5th EGM (15.07.2008)

Bhagwan Birsa Biological Park, Ranchi

DESIGN FOR DEERS ENCLOSURE IN RESCUE CENTRE BERWEY

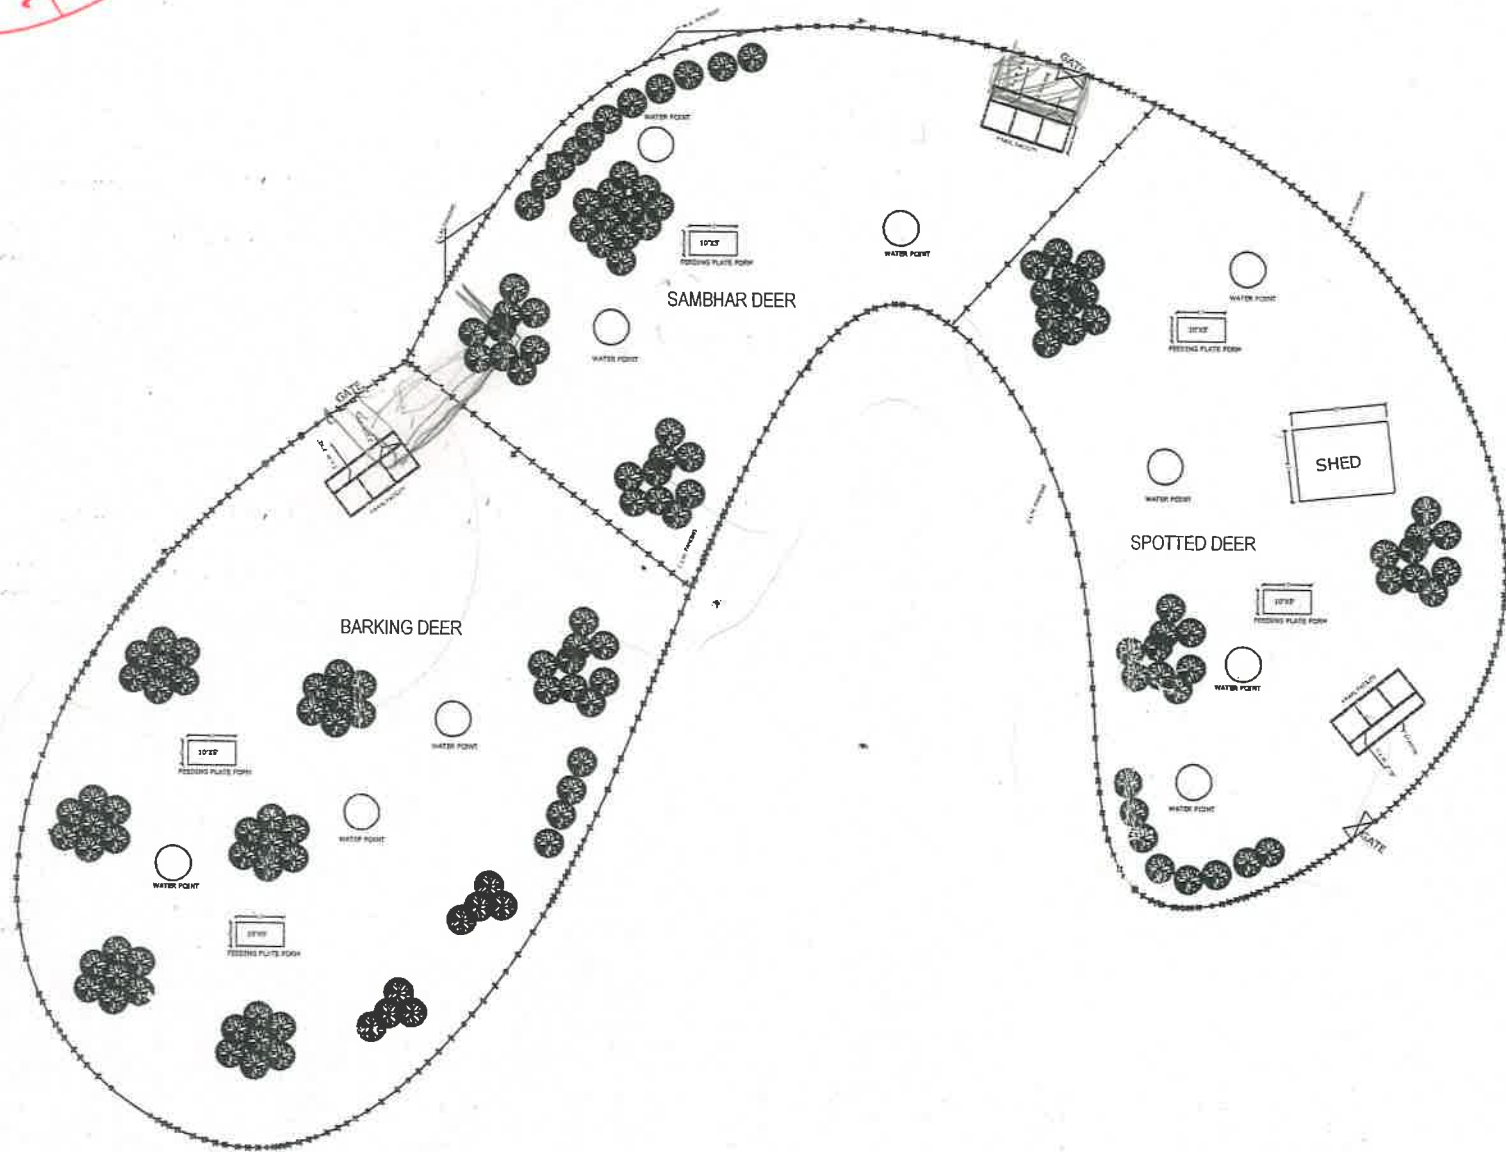
1. enclosure of barking deer and sambar may be inter changed.
2. The night shelter should be placed outside the fence preferably at the junction to the enclosure for the convenience of zoo keepers and maintenance purpose.
